Analysis of Cyberport Expansion materials presented to Legislative Council

分析數碼港就擴建項目 向立法會提交的文件

11 June 2021

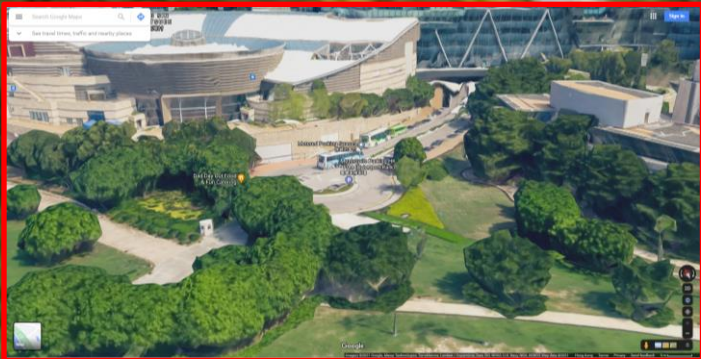
Permitted roof structures?
未有顯示天台結構物

Connection to Sandy Bay missing?
未有將海濱長廊連接至大口環?

Elevated walkway in the park area – obstacle and visual impact?
行人天橋設計會否造成障礙及影響景觀?

Concrete pier without shade?
碼頭缺乏上蓋?

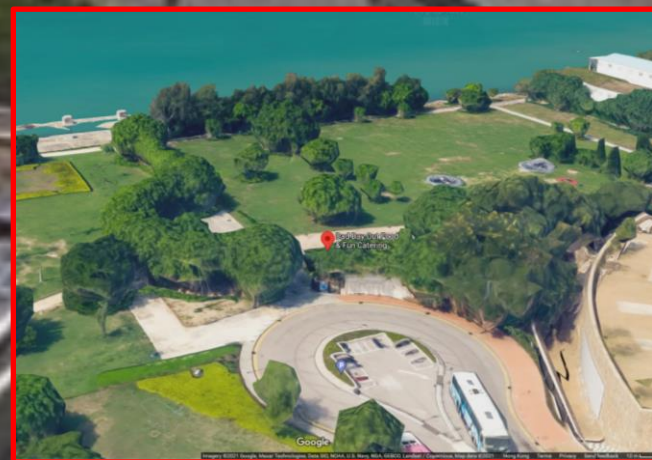
Entrance road for car park or emergency access only?
公園旁邊的通道是否只供緊急車輛使用？或是停車場出入口？

Grass replaced with concrete path without shade along the waterfront?
使用混凝土取代現有海濱的草地及樹木?

Trees and shade gone? Replaced with roundabout?
現有的樹木及遮陰地方被回旋處取代？
